**DEVIATION REVIEW  
AND DECISION FORM**

RETREAT AT TIMBERRIDGE FILING NO. 1

Section of ECM from Which Deviation is Sought:           DCM 6.4.2

## Two Cell Multi-plate Steel Single Arch Culverts (26'x8.6' equiv.) Flows FEMA Flows

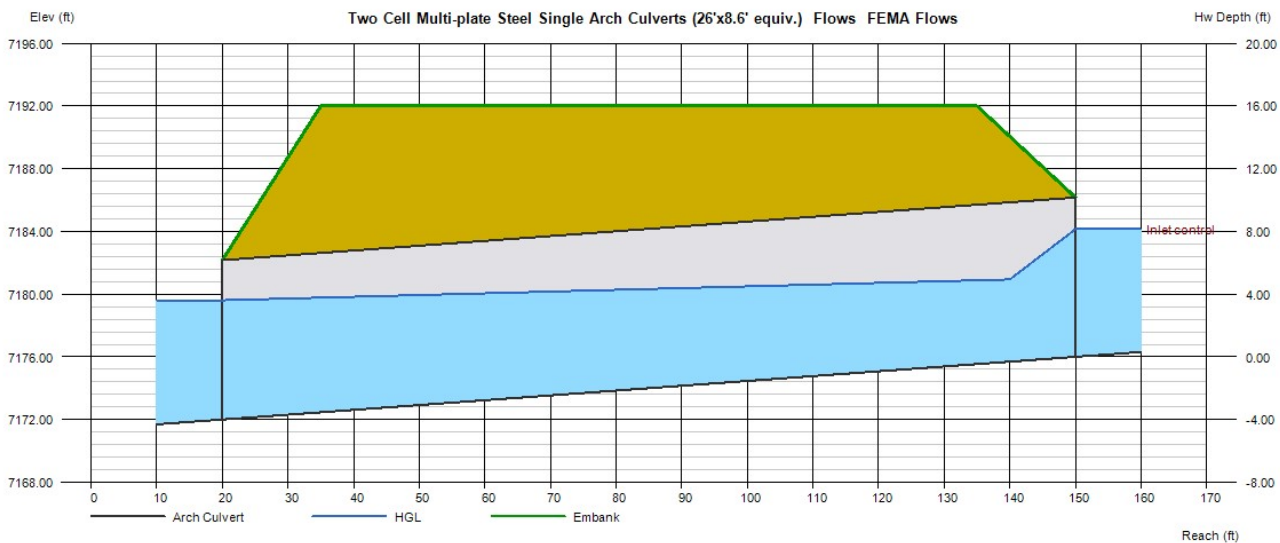
Is this correct? See comment letter regarding material.
